SITE PLAN
 SCALE: 1"=30'-0"

STRUTHERS-POLARIS RMG
 NEW BUILD
 847 STRUTHERS RANCH RD.
 COLORADO SPRINGS, CO 80912
 EL PASO COUNTY, COLORADO

Site Development Plan_V1.pdf Markup Summary

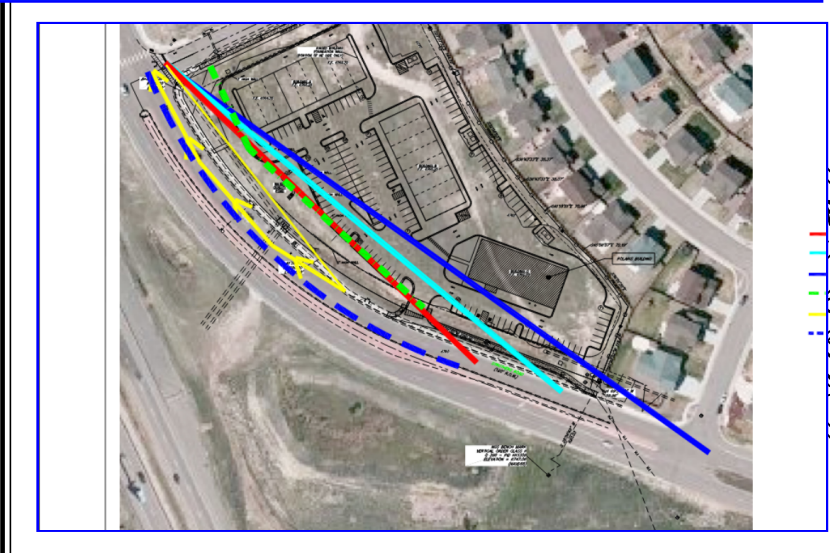
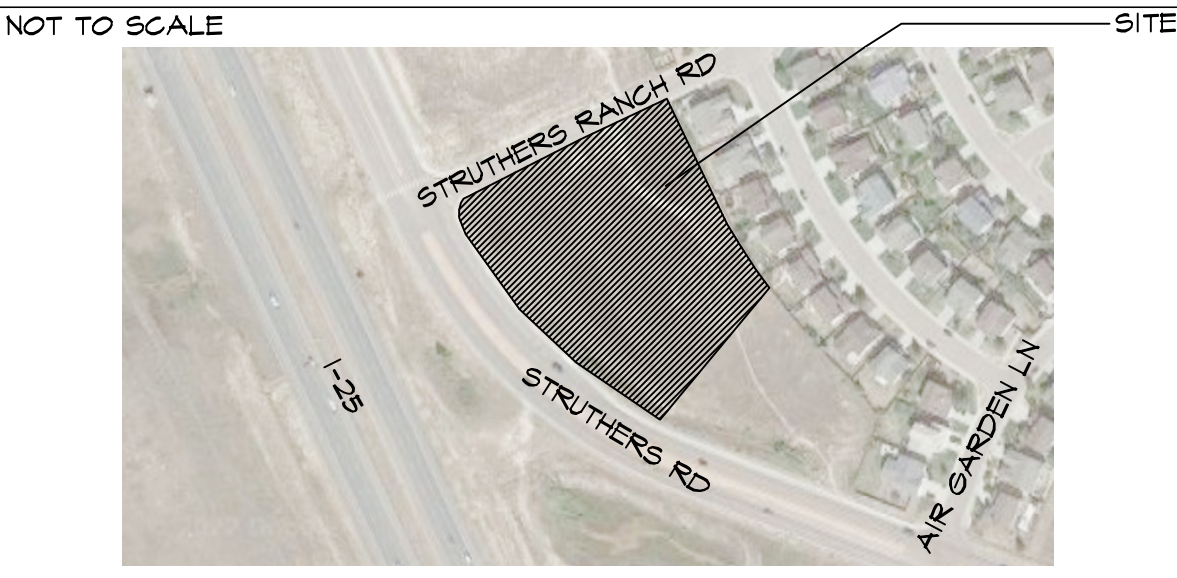
Show on plan:
 Location of all existing and proposed utility lines and associated infrastructure
 Location of all no-build areas, floodplain, drainageways and facilities
 Location of existing and proposed water and wastewater infrastructure, including well and septic locations, if applicable
 Provide the layout and location of all off-street parking, loading and other vehicular use areas, unless otherwise depicted in detail on a separate parking plan. If depicted on a separate parking plan then depiction of the parking areas are required
 Any additional information required pursuant to any associated conditions of approval or plat notes.

Show & label the existing crossspan
 Label access curb radius.
 Coordinate with traffic engineer to determine if stop sign at driveway entrance is needed.

Please add this note on the plan:
 The parties responsible for this plan have familiarized themselves with all current accessibility criteria and specifications and the proposed plan reflects all site elements required by the applicable ADA design standards and guidelines as published by the United States Department of Justice. Approval of this plan by El Paso County does not assure compliance with the ADA or any regulations or guidelines enacted or promulgated under or with respect to such laws.

The Traffic Analysis noted that the right turn lane threshold is met. Provide the right turn lane or submit a deviation request for the ECM Administrator's consideration.

update label to identify the width of existing sidewalk. If existing is 6' wide then a transition taper may be required to go down to 5' wide proposed sidewalk.

Show sight distance easements required on site plan per traffic study. See snippet. Note: there shall be no obstructions that are taller than 30' above Struthers Road flowline per ECM 2.3.6.G.2. It appears parking lot retaining walls are already exceeding allowed heights per Struthers Road flowline elevation of 6757'.

Total count is 29 with 27 standard stalls and 2 ADA stalls

Provide plan preparer name, telephone number, and email

11 RETAINING WALL DTL (6'-0" TO 12'-0") HIGH
SCALE: 1/2"=1'-0"

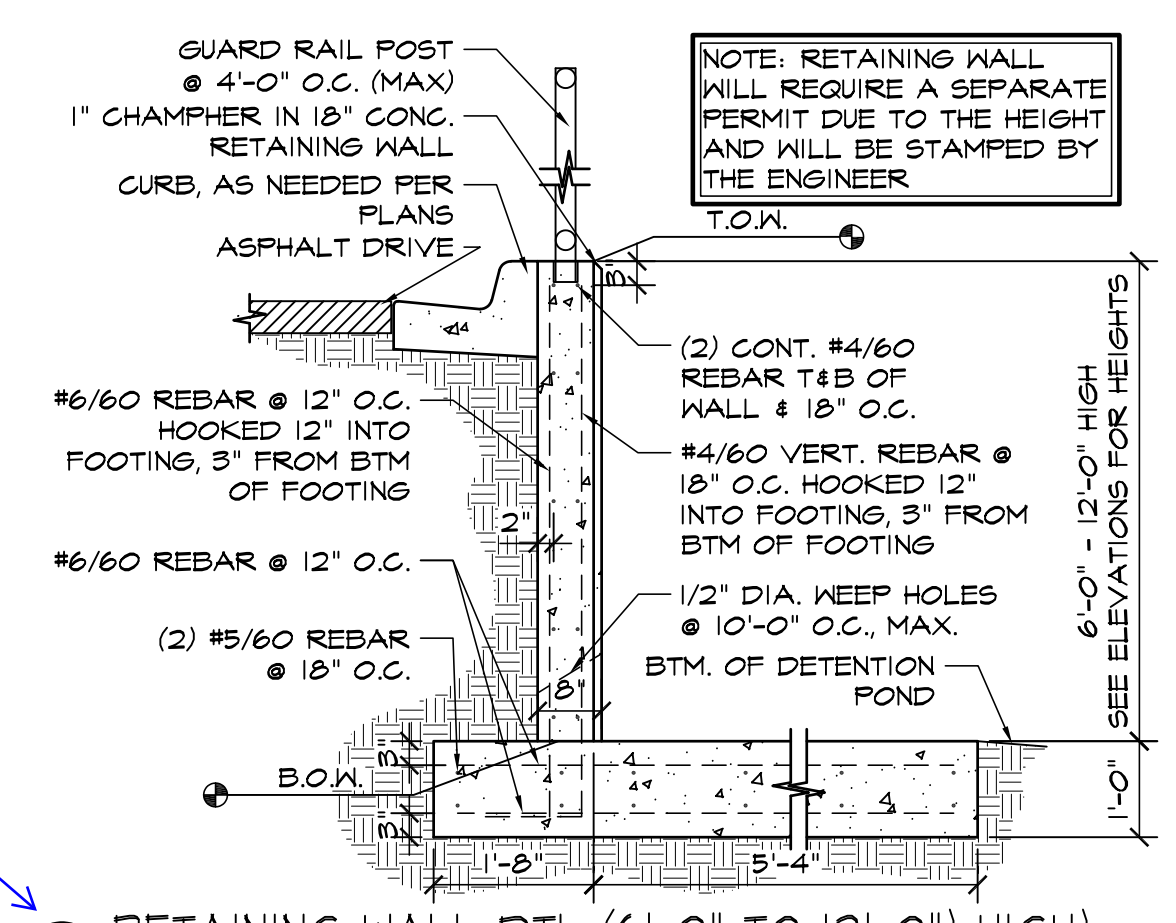
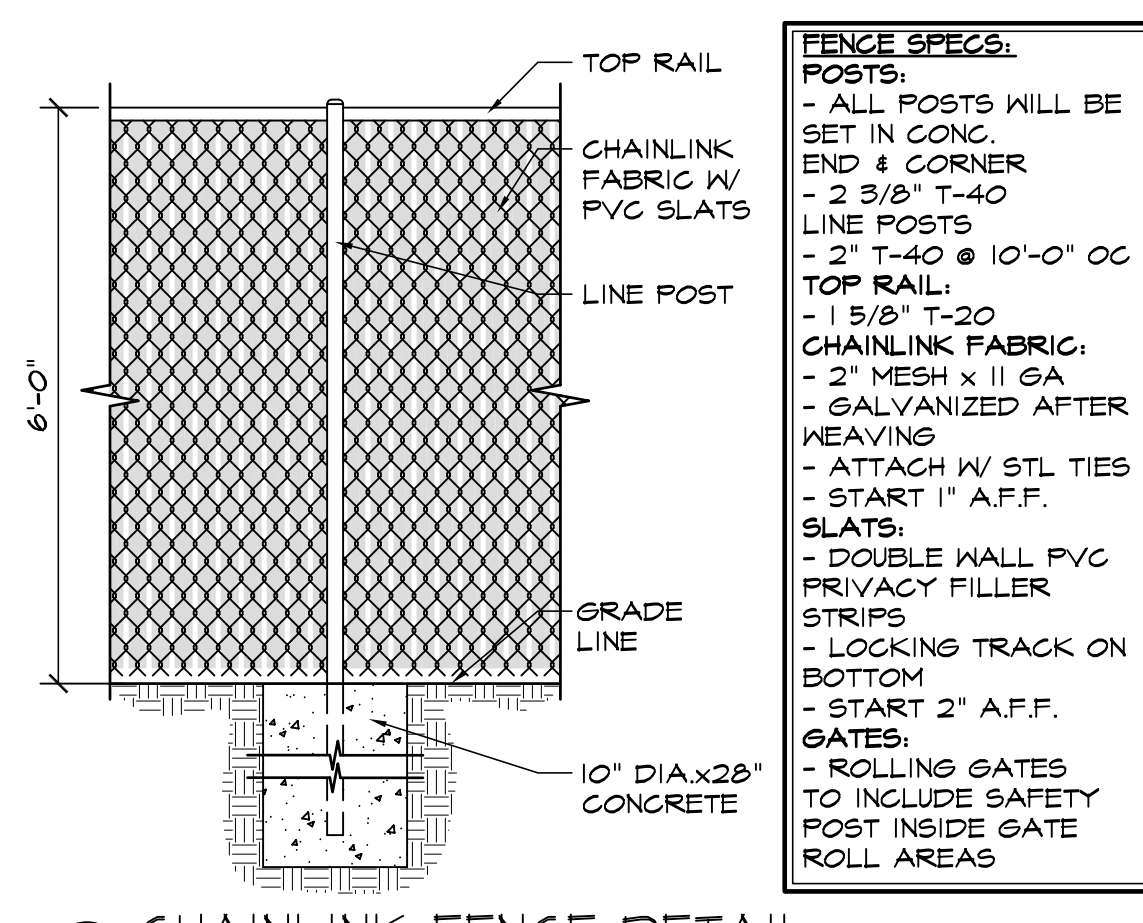
Note: a building permit is required for retaining walls that are 4' or taller.
